Architectural Design Statement

SYDNEY OPERA HOUSE LOWER CONCOURSE IMPROVEMENTS

LOWER CONCOURSE, SYDNEY OPERA HOUSE,
BENNELONG POINT, SYDNEY

31.07.2019

Figure 6: Proposed glazing line and internal dining area configuration

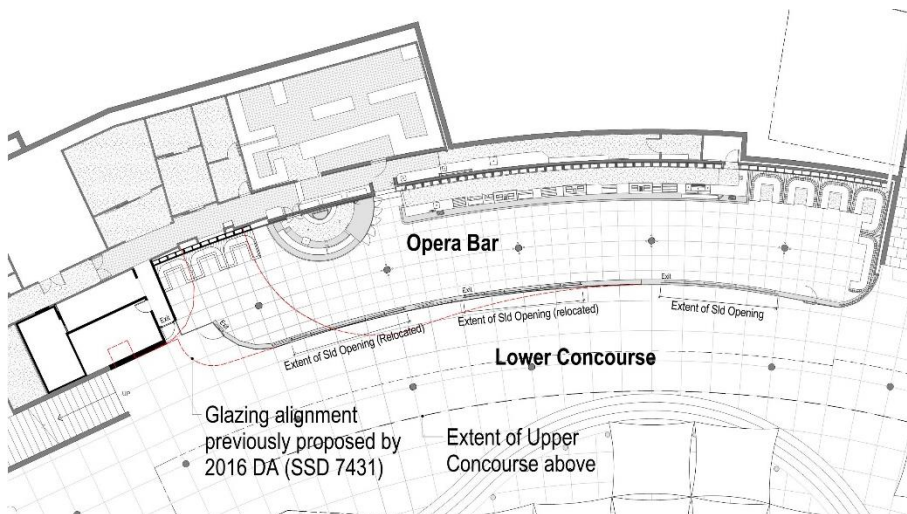
The proposal improves pedestrian flow around the concourse by removing the existing pinch point between the existing glazing line and mushroom columns. Refer to *Figure 6*. At the pinch point the existing clear dimension between the glazing and the inside face of the mushroom column opposite is 3.13m.

Figure 12: Indicative cross sections showing existing umbrellas and proposed shade structure configurations in three different locations: Opera Kitchen (Top), Opera Bar Upper (Middle) and Opera Bar Lower (Bottom)

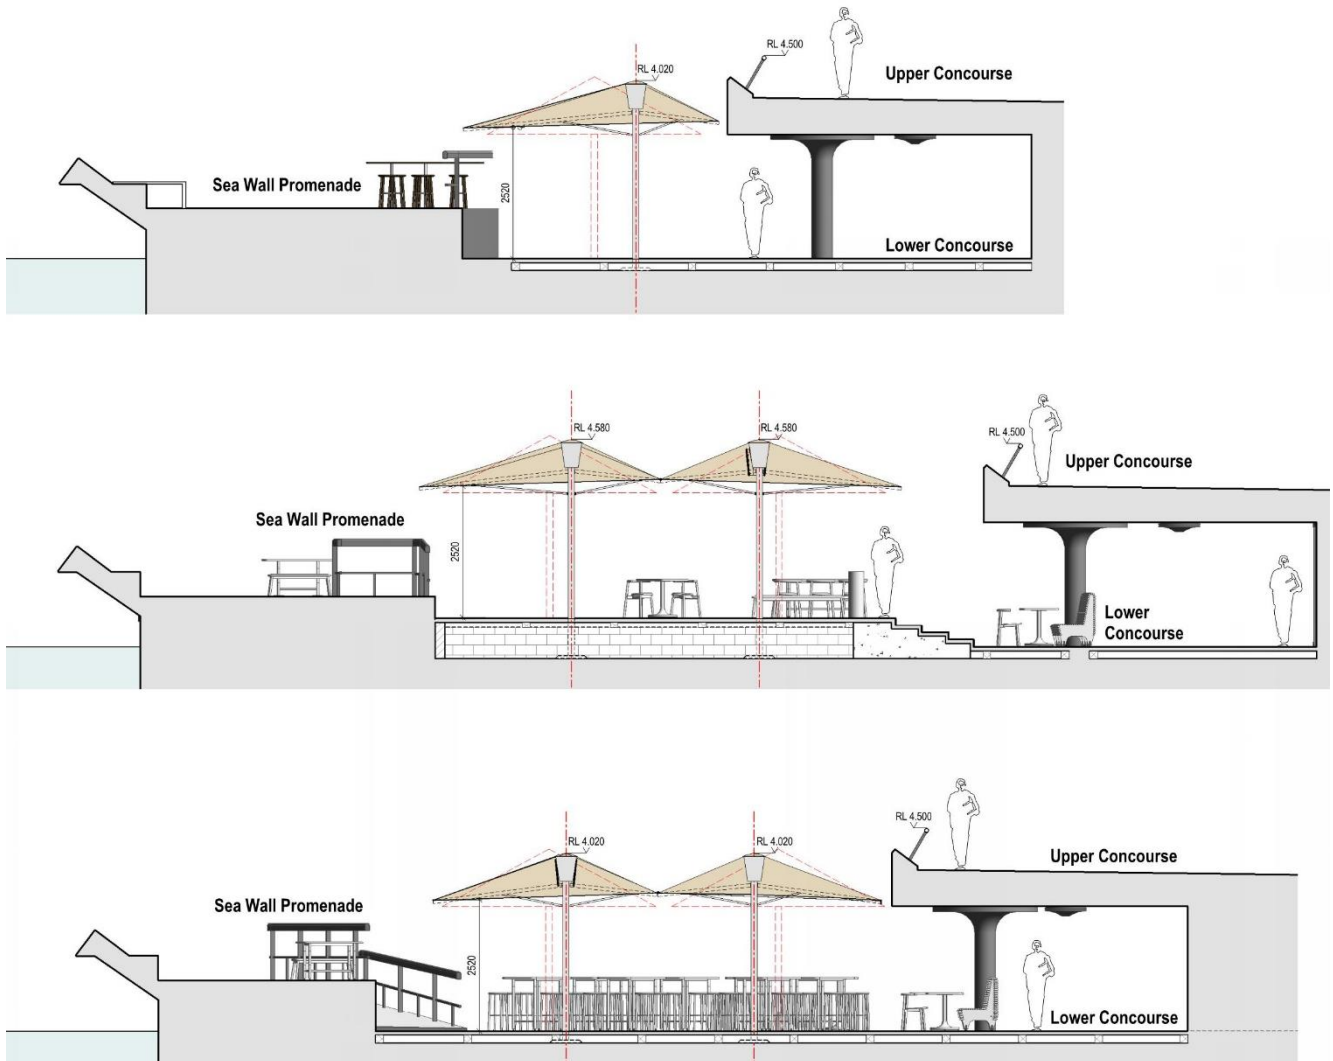
With reference to *Figure 12* it can be seen that the proposed shade structures, whilst similar in footprint, provide a slightly increased clearance from the finished paving level to the lower edge of the structure and fabric.

The clearances to the underside of the proposed structures and the existing umbrellas can be seen by review of the cross-sectional diagrams included at *Figure 12*.

By review of the cross-sectional diagrams included at *Figure 12* it is evident that there is no point where the shade structure actually comes into contact with the Upper Concourse Parapet.

Figure 33: Existing umbrella gusset detail

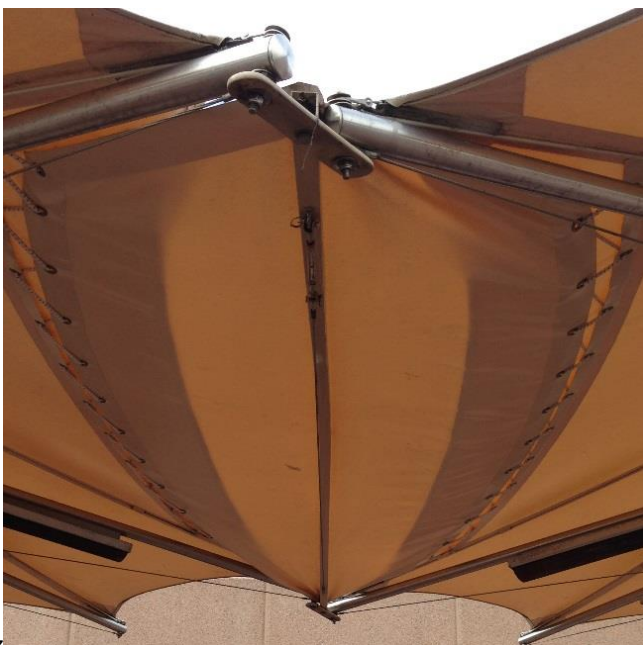
The existing umbrellas incorporate gussets and gutters that are effectively stitched in between the main umbrellas. Refer to *Figure 33*. These perform poorly from a functional perspective and are unsightly aesthetically.

In response the proposed design incorporates integrated gussets that are proposed to be cut from translucent fabric. By comparison the proposed connection detail is refined and integral with the design of the proposed shade structures.
